**September 10, 2024**

**The Reserves at Grand View Heights – Proj. 22-3262**

**ADDENDUM NO. 3**

**A ENLARGED TRASH ENCLOSURE PLAN**  
1/4"=1'-0"

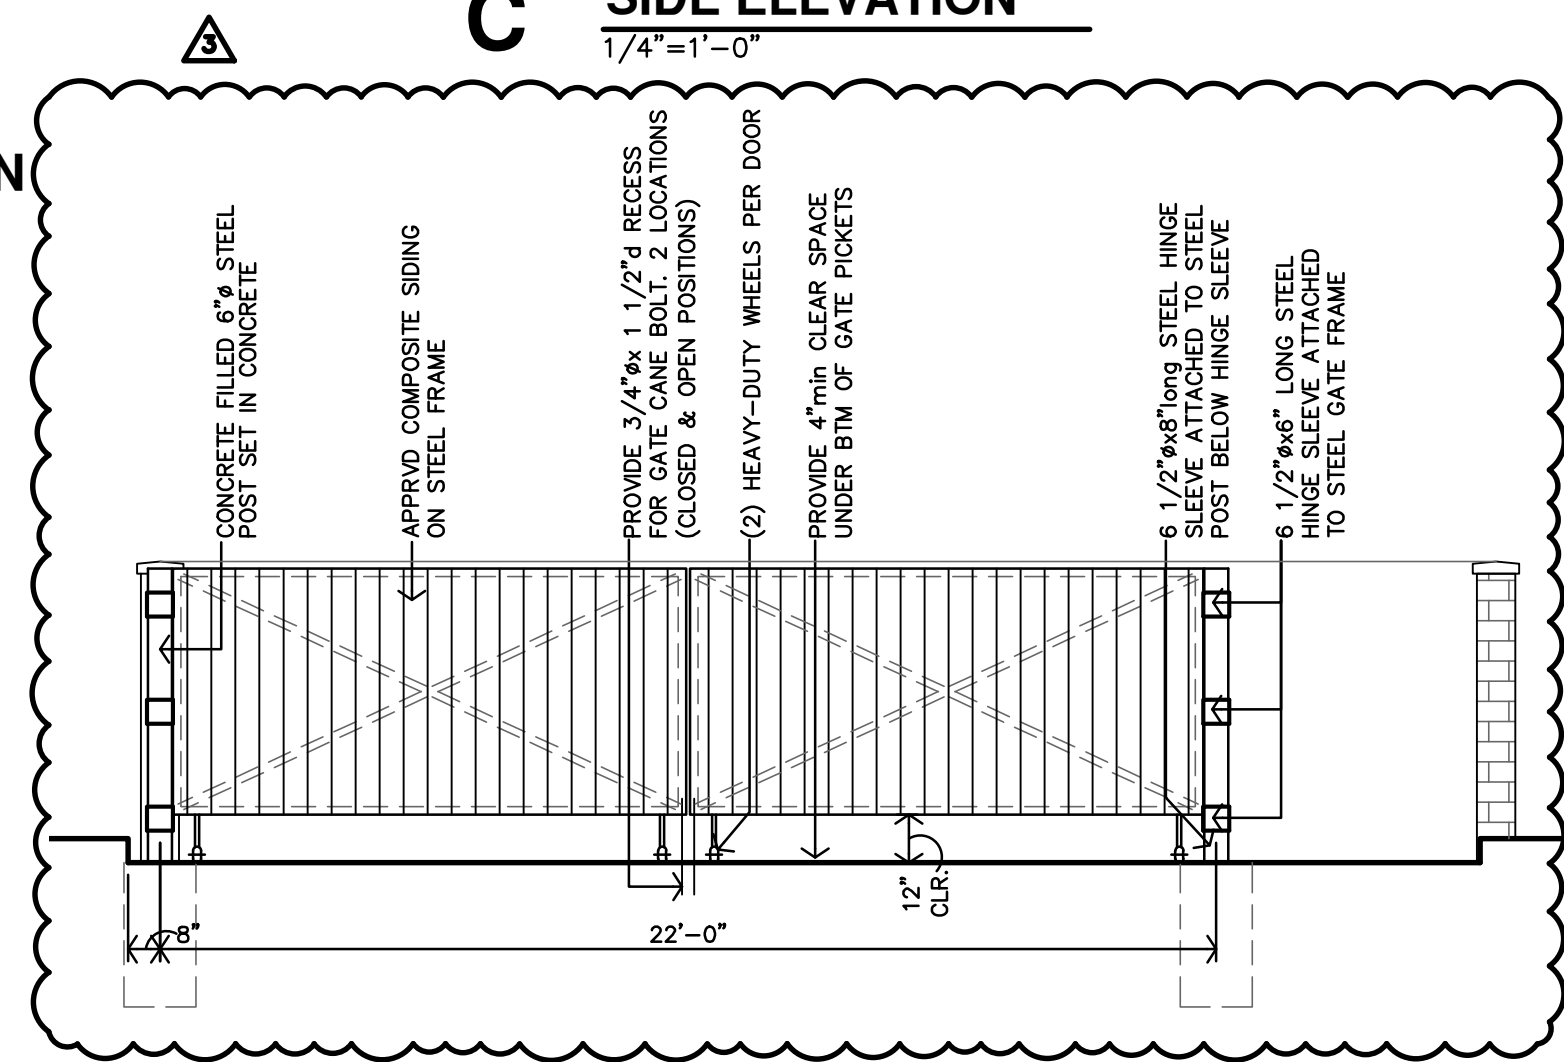
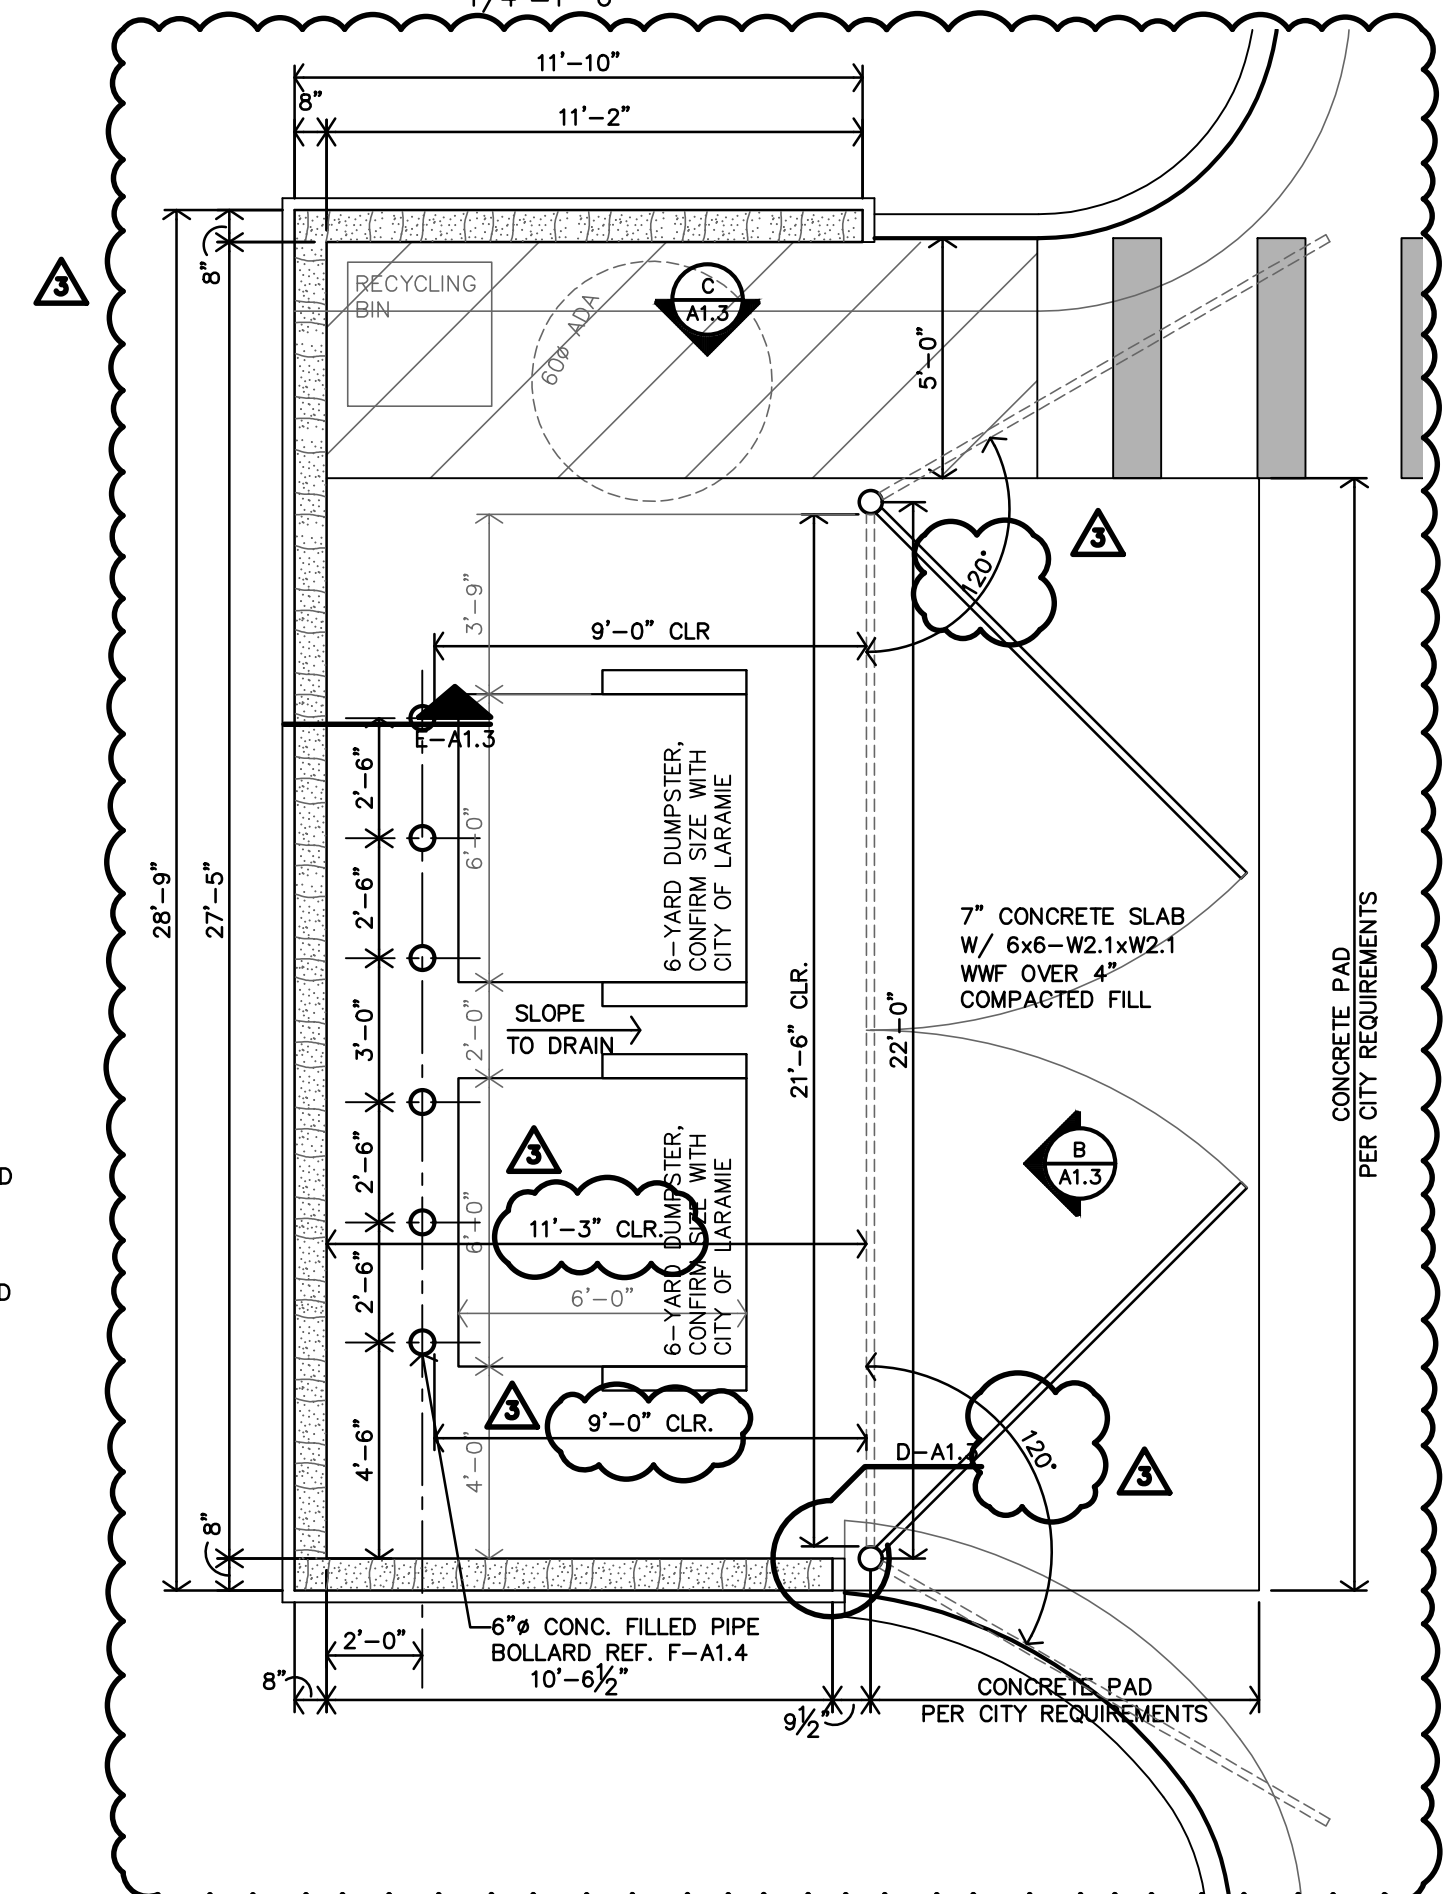
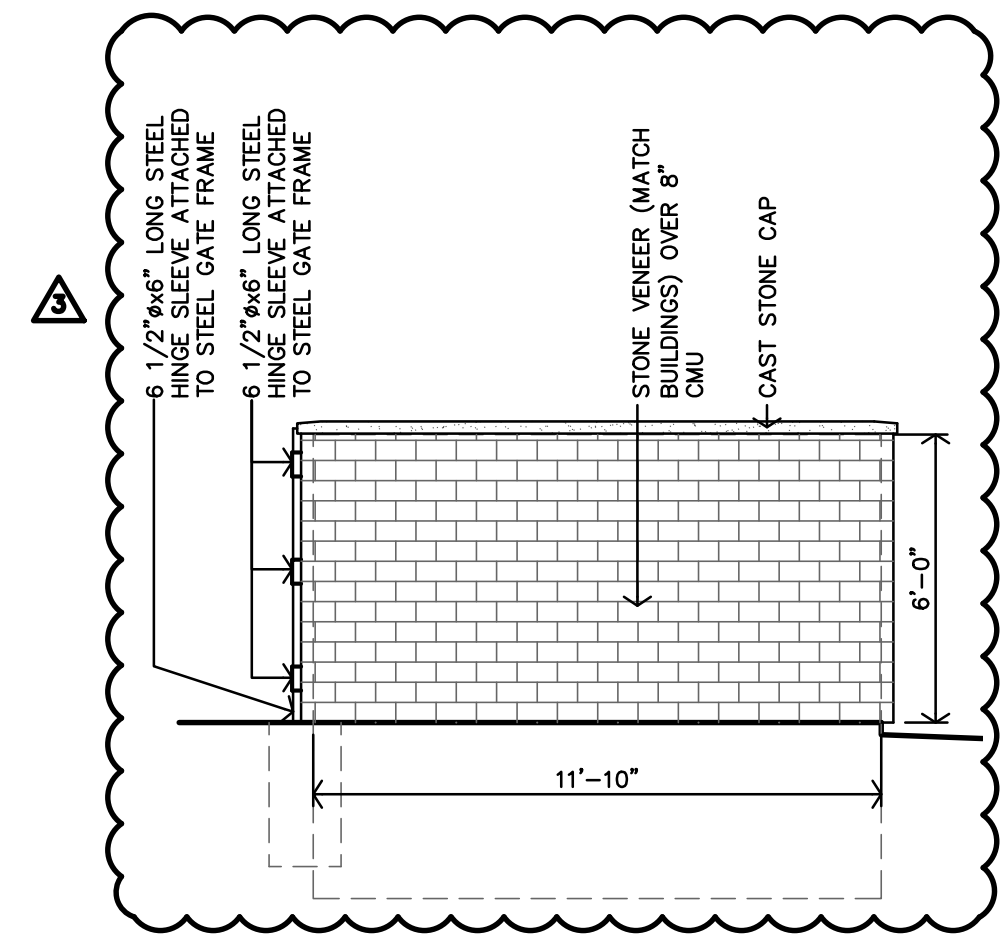
3. Sheet A1.3
  - a. Trash Enclosure has been enlarged (North wall shifted north), and dumpsters/bollards shifted north, to provide proper clearance around the dumpsters. Reference revised details A, B & C

SITE PLAN  
1" = 20'-0"

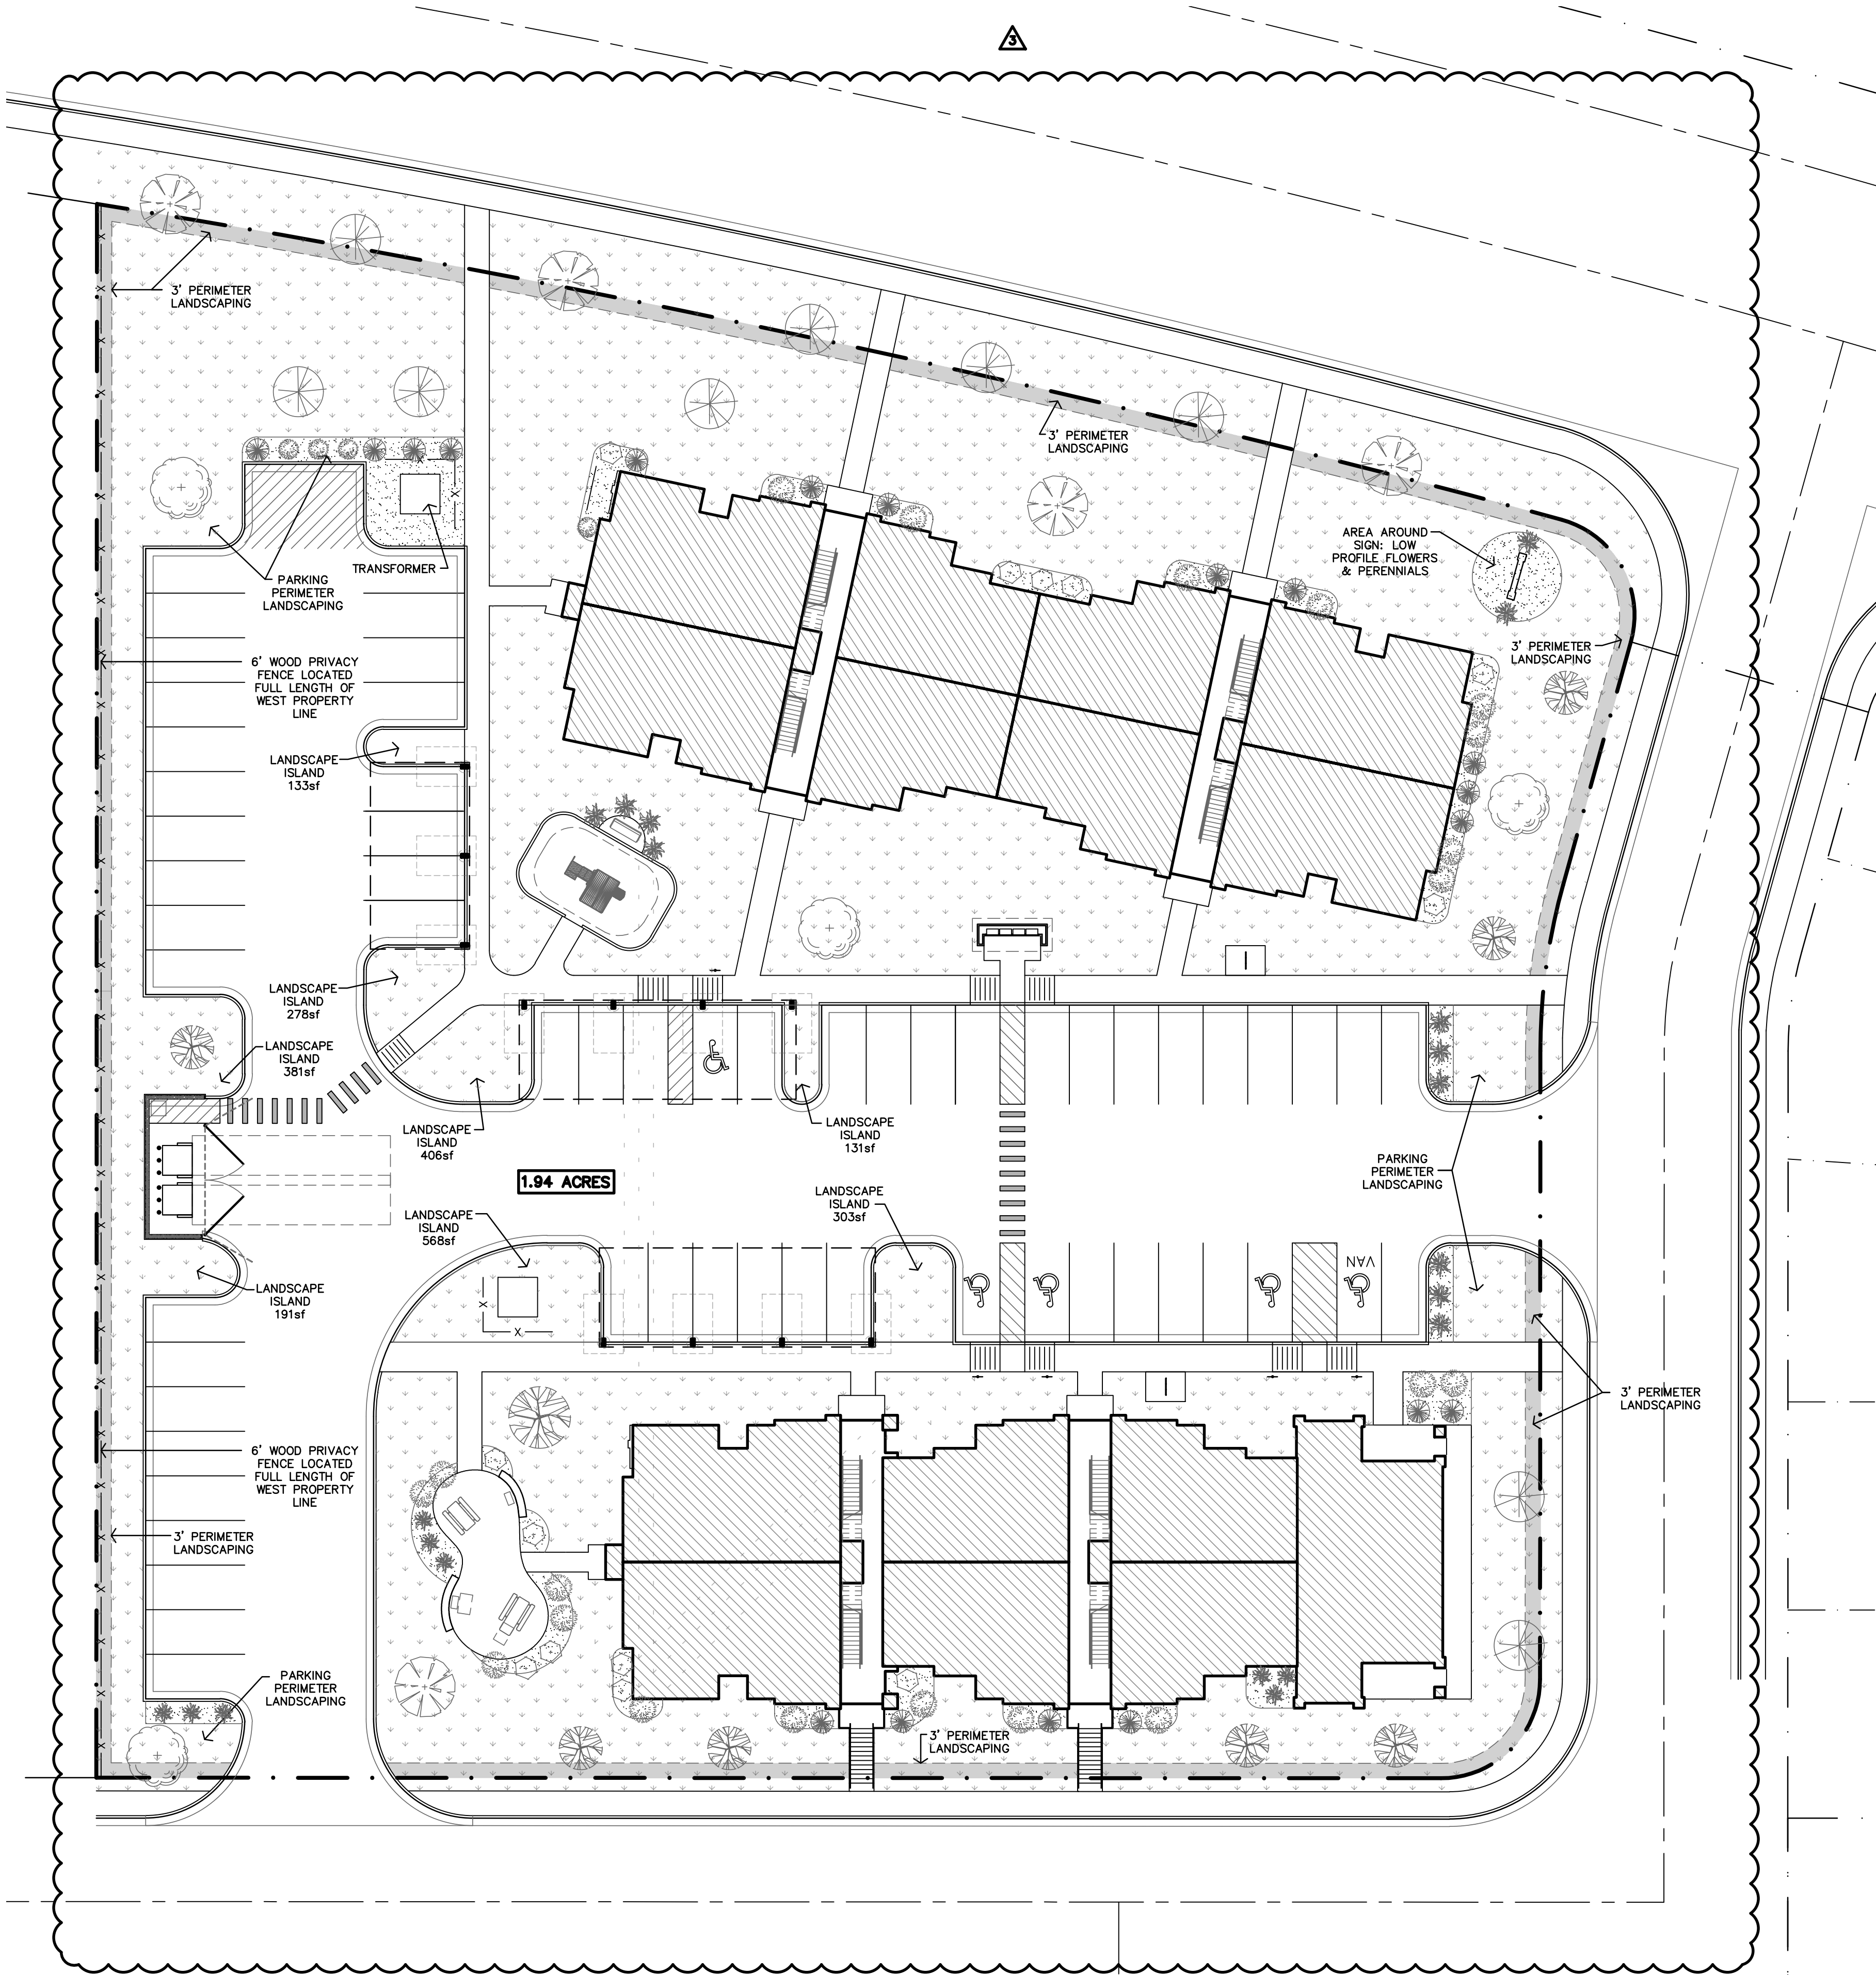
- b. Monument Sign size has been adjusted, made smaller. Reference revised details G, H, J & K.
4. Sheet L1.1
  - a. Entire Plan has been updated to include additional plantings and landscaped areas per Laramie Municipal Code.

- b. Irrigation note has been added
  - c. Landscaping requirements calculations have been updated
  - d. Landscape Units Awarded Chart has been updated.
